Docket Item #9
DEVELOPMENT SPECIAL USE PERMIT #2002-0050
ALEXANDRIA TOYOTA

Planning Commission Meeting
March 4, 2003

- ISSUE:** Consideration of a request for a development special use permit, with site plan, to add service bays and a parking structure to the existing automobile sales facility.
- APPLICANT:** Alexandria Toyota Inc.
by Harry P. Hart, attorney
- LOCATION:** 3750 Jefferson Davis Highway
- ZONE:** CDD-7/Coordinated Development District

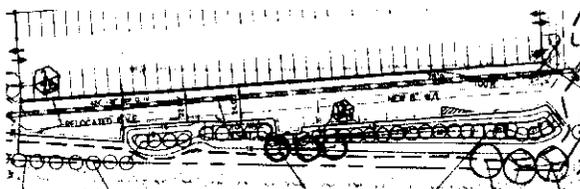
1. The applicant flipped the footprint of the garage so that the 4 ½ story portion of the structure rather than the 5½ story portion fo the structure is adjacent to the residential units
2. The applicant provided a red stucco finish with punched window treatment.
3. The applicant widened the landscape strip between the residential buildings and the garage, providing a slight berm and additional opportunities for landscaping; and, the applicant also agreed to provide additional landscaping along Four Mile Run to buffer the view of the garage from the north.

While the changes made by the applicant are all positive, staff does not believe they go far enough to mitigate the visual impact of the mass and scale of the proposed parking garage. Therefore, staff is recommending that two levels of the garage be removed to reduce the overall height of the parking garage, reducing the height from 48 feet to a maximum of 32' or from 5 ½ levels down to 3-3 ½ levels. This reduction in height would significantly reduce the visual impact of the garage on the apartments and reduce the visual massing from adjacent public areas. Reducing the garage by two levels will eliminate 231-304 parking spaces from the garage (average of 116-152 spaces per level), resulting in a total of 419-492 parking spaces in the garage.

Applicant's Proposed Landscaping

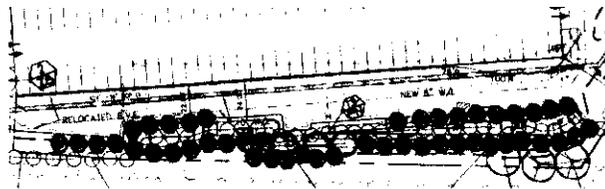
Staff had recommended that the applicant provide an increased buffer area with berming along the property line adjacent to the apartments as another means of buffering the apartment use from the proposed parking garage. The applicant removed and/or relocated approximately 45 to 50 parking spaces to provide a buffer area varying between 12 and 25 feet deep. Although the berming was not as substantial as recommended by staff and measures only about five feet tall, it does provide somewhat of a modest psychological and physical separation between the two sites. The applicant has proposed a row of Austrian Pines atop the berm. Staff is recommending that a variety of additional evergreen trees be planted within the buffer strip and that the minimum height of the trees upon installation be at least 14 feet tall so that there is immediate screening of the garage's lower levels.

Exterior Appearance

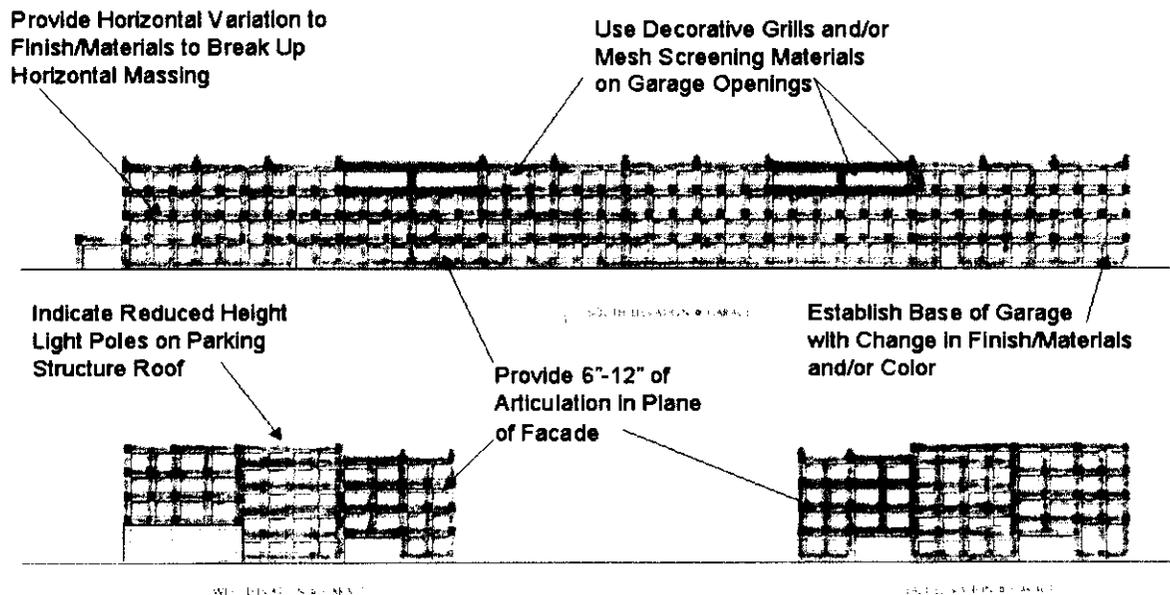
The appearance or exterior design treatment of the parking garage is critical to minimizing the visual impact of the garage. Typically, garages are constructed of poured in place concrete or are prefabricated concrete. They traditionally are a gray color with long spandrel openings between the decks and are very unattractive, particularly when they are sited in urban settings. Staff recommended that the parking garage would have to have an enhanced design appearance utilizing traditional building colors consisting of such colors as brick red, buff colored precast concrete and other earth tone colors. In addition, staff recommended that the garage openings be reduced in size consistent with punched window openings. The applicant did respond by providing exterior design treatment that complied with these recommendations. However, the design of the garage needs attentional attention to resolve issues of mass, scale and exterior building materials. Staff is recommending a number of design guideline requirements to further refine the exterior design treatment of the parking garage. It is staff's goal to have the parking garage appear more as a building than a parking structure. Several of the recommendations are focused on breaking up the building's massing so that bays and horizontal elements appear more as the scale of a traditional building.
